City of West Linn
PRE-APPLICATION CONFERENCE MEETING
Notes
April 4, 2013

SUBJECT: Three lot minor partition at 1700 Santa Anita Drive

ATTENDEES: Applicants: Phil and Shawn Gentemann, Bruce Goldson
Staff: Peter Spir (Planning Department), Khoi Le (Engineering Division)

Partition of Property and Lot Layout

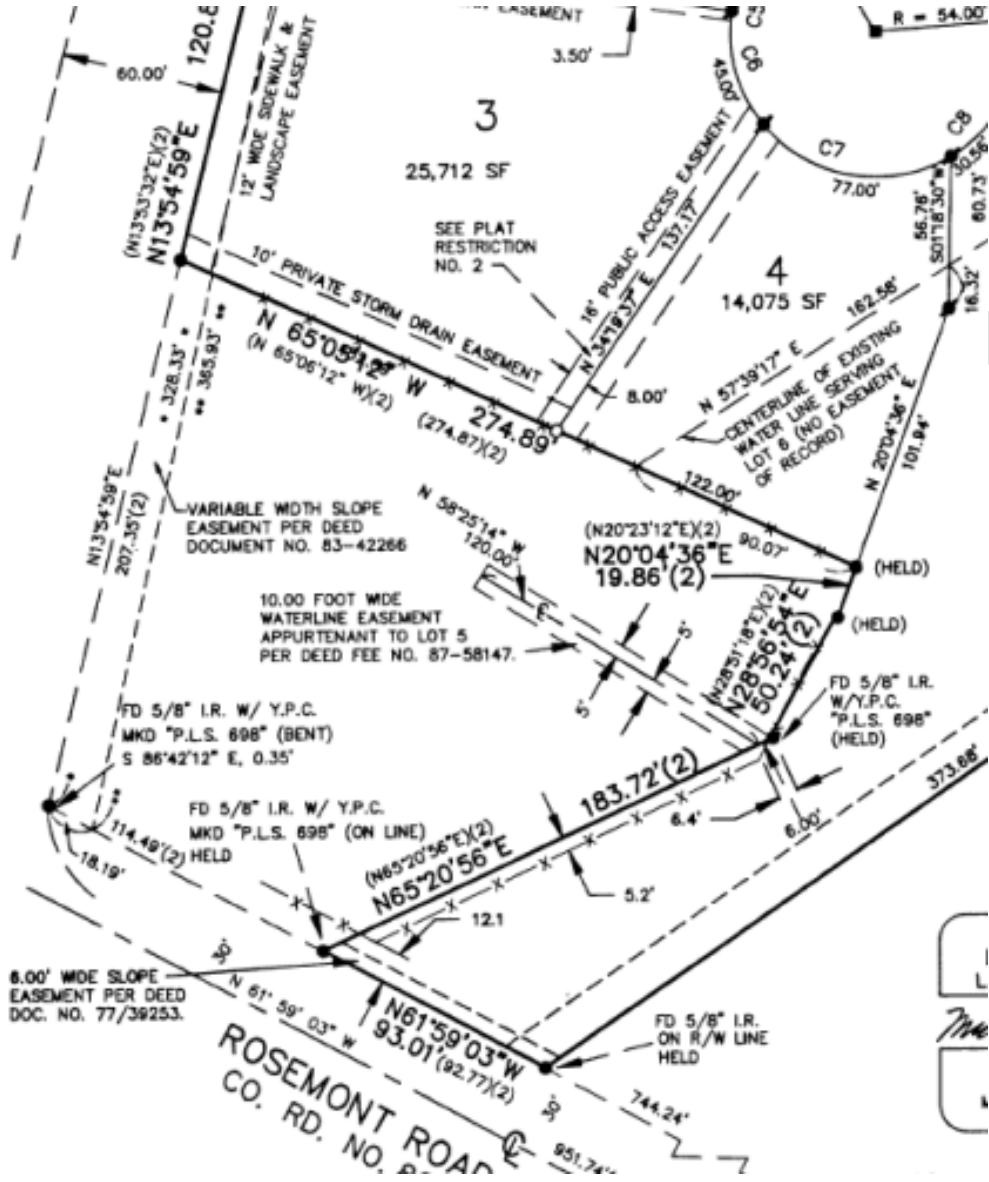
The three lots will be distributed around the site. Access to the homes will be via a shared driveway and the existing curb cut on Santa Anita Drive. All lots will meet the R-10 minimum lot size as well as the dimensional requirements of the zone.

The applicant shall must provide the necessary calculations to demonstrate that the development is attaining at least 70 percent of the maximum allowable density of the R-10 zone.

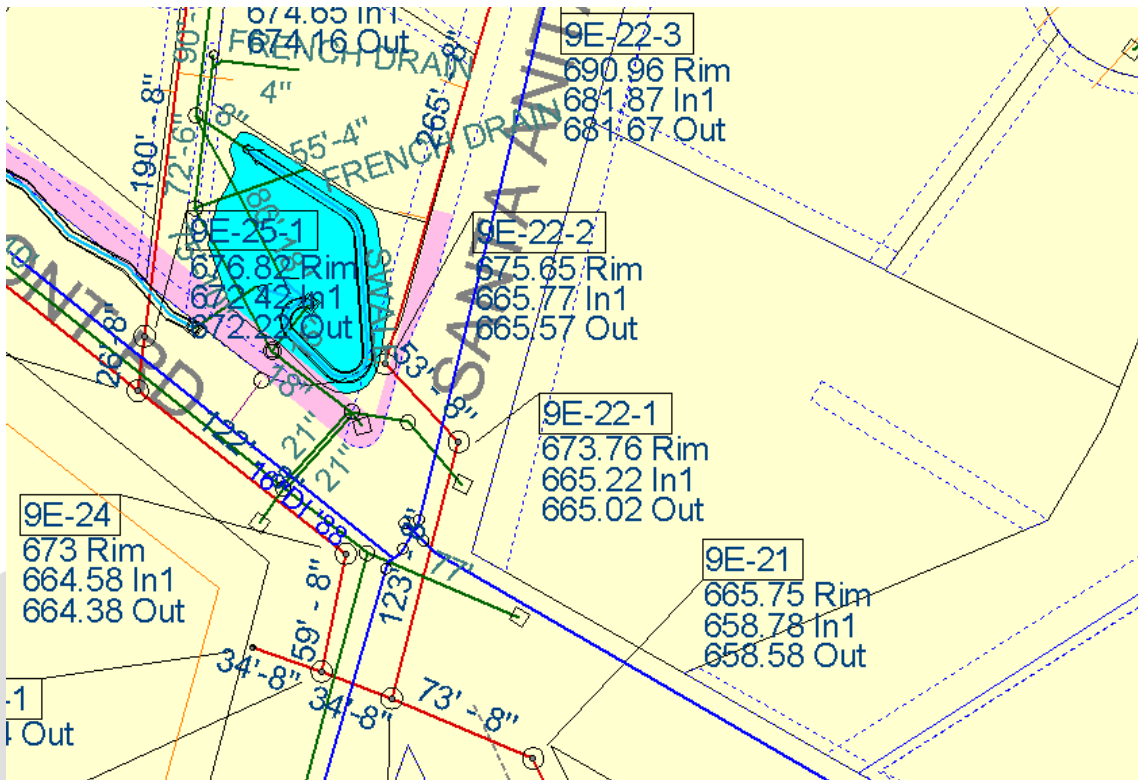
The applicant shall verify the status of the water easement on lot 2.
